Improved cylinder head gasket for type H engine

Saab 99 Service Information

Nr/No. 234-52 sE

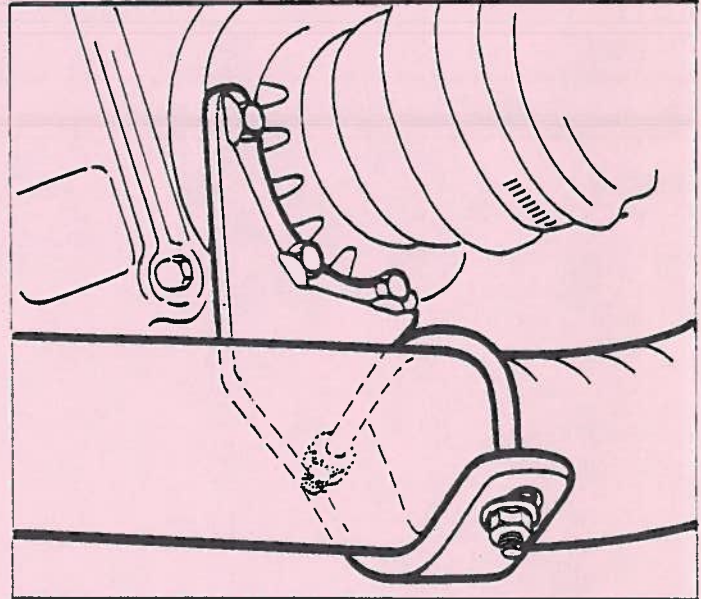
A new exhaust pipe mounting that supersedes the earlier version has been produced as a spare part. The new mounting should be fitted to cars on which oil leakage occurs at the rear final drive cover.

1. Remove the exhaust pipe mounting.
2. Remove the final drive cover and replace the gasket. Check the fit of the studs. If the studs have worked loose, they should be replaced by bolts Art.No. 80 82 935.
3. Fit the new mounting on the right-hand side at the differential bearing seat. Use the new longer bolts, Art.No. 80 82 992, and locking washer Art.No. 75 14 631. Check that the exhaust pipe runs correctly and is not strained. Fit the clamp.

99 MODEL: SUBJECT: RADIATOR FAN MOTOR

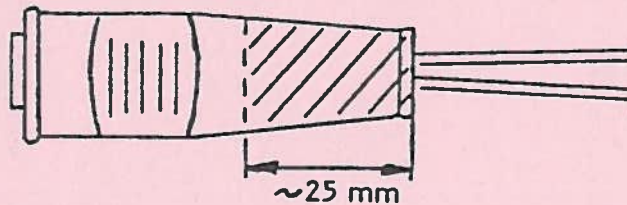
A new cooling fan motor manufactured by Magnetti Morelli is being fitted in production and also supersedes the former type as a replacement part. Part No. 7540263.

When a fan motor of the previous type is replaced by the new unit 7540263, it is necessary to modify the electrical connector to prevent chafing of the leads.

Shorten the rubber sleeve around the connector by 25 mm with a knife or scissors. Take care not to damage the cable insulation.

Cylinder head bolts

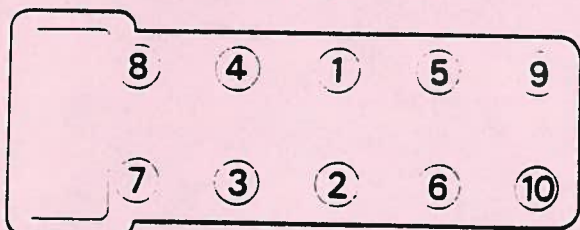
A new type of cylinder head bolt, 75 18 343, with flange and external TORX head has been introduced into production between engine numbers E 42621 and 46906, and then as from engine number E 53614.

The tightening torque is the same as for the earlier cylinder head bolt 93 54 598.

New type of chain tensioner and chain guide

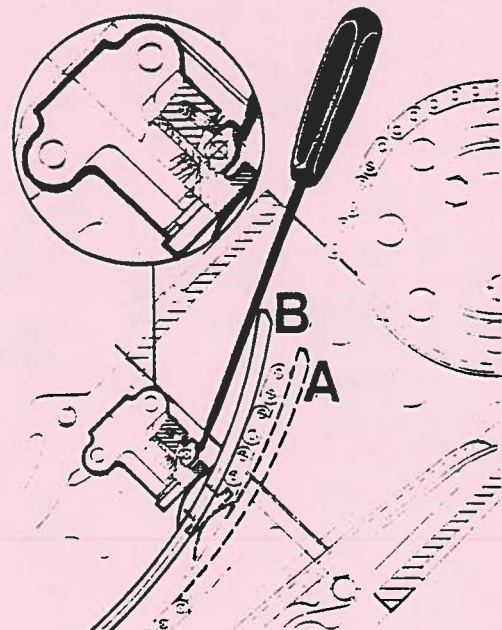
The most significant difference is that the present chain tensioner consisting of a single component is replaced by one comprising two components, i.e. tensioner 93 58 672 and the associated chain guide 93 58 680 pivoted on the same cylindrical pin as the present chain tensioner.

When repairing cam transmissions especially on carb. engines, this new tensioner should always be used instead of the old type (93 58 136).

MODEL 99: SUBJECT: OIL PRESSURE RELIEF VALVE

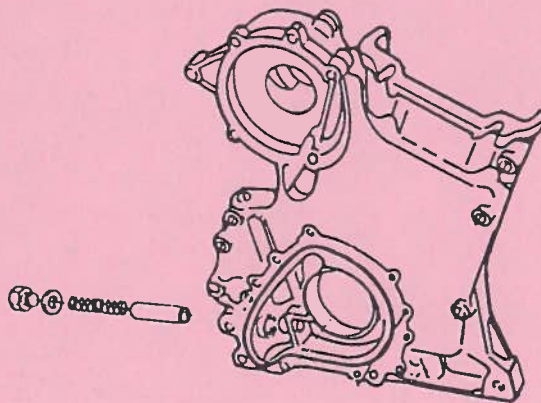
The oil pressure relief valve on "H" engines was subject to slight changes during the 1983 model year from Engine number D90624.

The later valve and its corresponding bore in the timing cover is 0.2mm larger than the earlier type and it is essential, therefore, that an early valve is not used in a late timing cover or low oil pressure will result.

To reduce the possibility of confusion, the early timing cover has been superseded to the late cover (7508351) and matching relief valve (7508328).

SUBJECT: CHECKING THE SECURITY OF THE PRE-HEATER
ELEMENT - CARBURETTOR CARS.

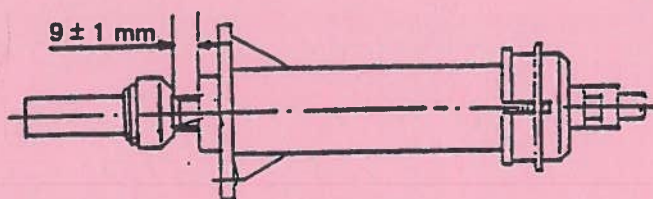
On M82 and early M83 cars, it is possible that the thermostatic pre-heater element, situated at the carb. intake can work loose.

Adjust the element so there is a gap of 9mm between it and the plastic sleeve - see diagram. Lock the element in place with a few drops of Loctite 1S496 and reassemble.
